BRIDGE RAIL LAYOUT ~ UNIT 3 (SPANS 15 THRU 23)

SHOP DRAWING REVIEW

MAT'L : SEE GN-1		FIELD BOLTS		
HOLES : 22Ø (7/8") U.N.O.		GRADE: A325		
WELD :				
ELECTRODE : E70XX				
PREP : SEE GN-1				
PAINT : SEE GN-1				
REV.	DATE	BY	DESCRIPTION	CHK
1	11/01/05	JM	RE-ISSUED FOR APPROVAL	BH
0	18/06/04	JM	ISSUED FOR APPROVAL	BH
WORK NETC 4 RAIL-BRIDGE RAILING VT. ROUTE 78 OVER MISSISQUOI BAY ALBURG - SWANTON, VERMONT				
DRAWING BRIDGE RAIL LAYOUT - UNIT 3 (SPANS 15 THRU 23)				
SCALE: N.T.S.		SHEET E26		
DRAWN: JM		CORPORATION PITTSFIELD MAINE		JOB 050004
CHECK: BH

DETAIL 2
TYPICAL RAIL SPLICE

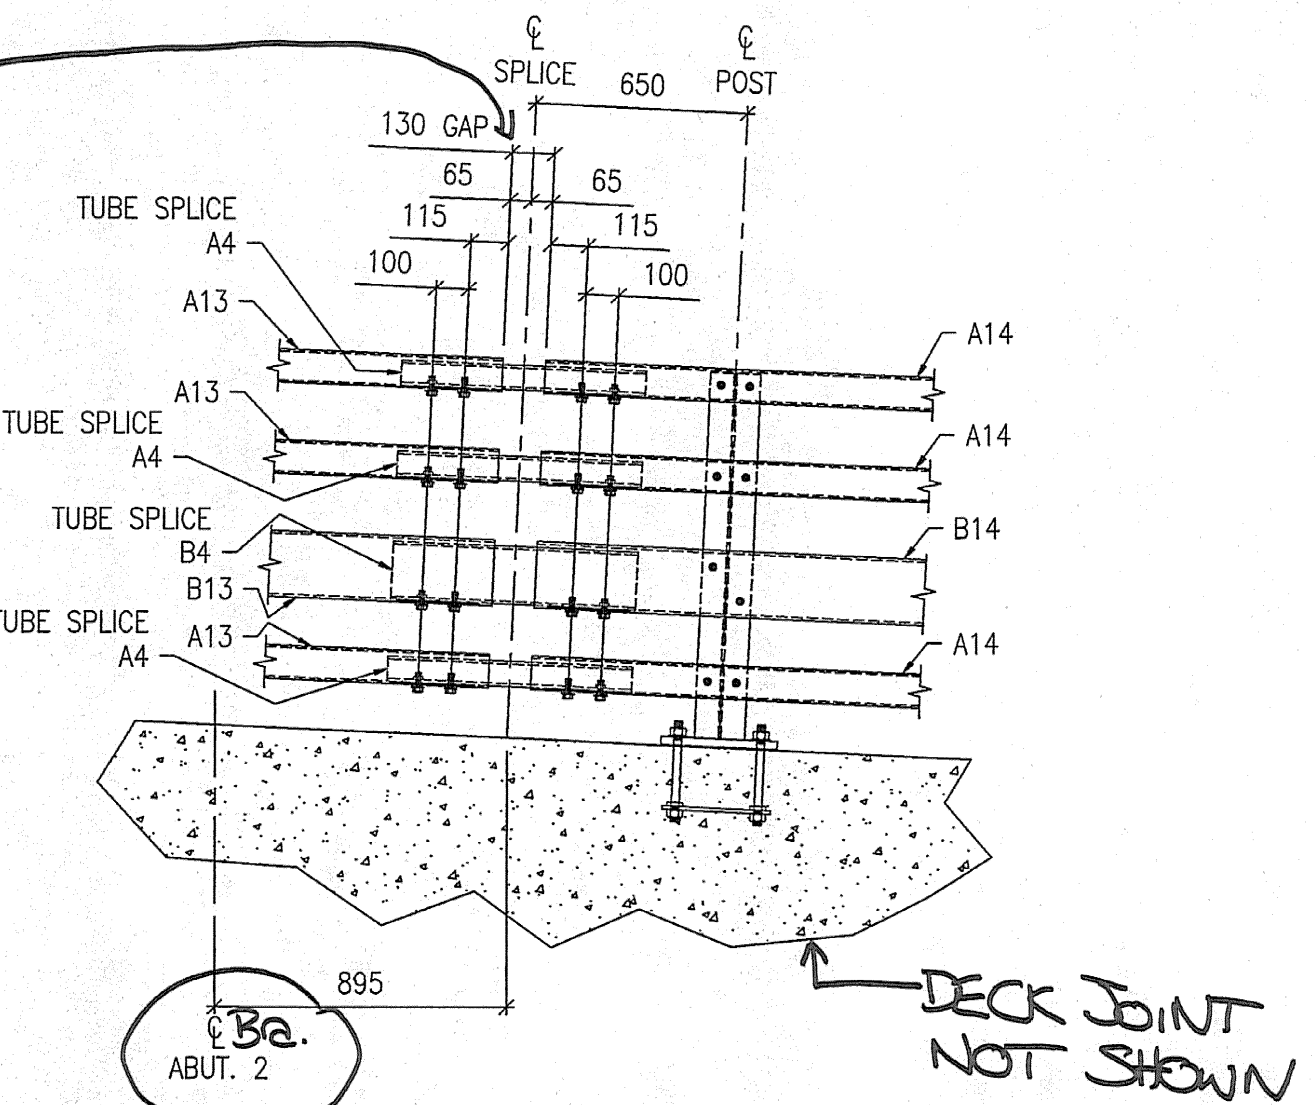
ADD "@ 7°C"
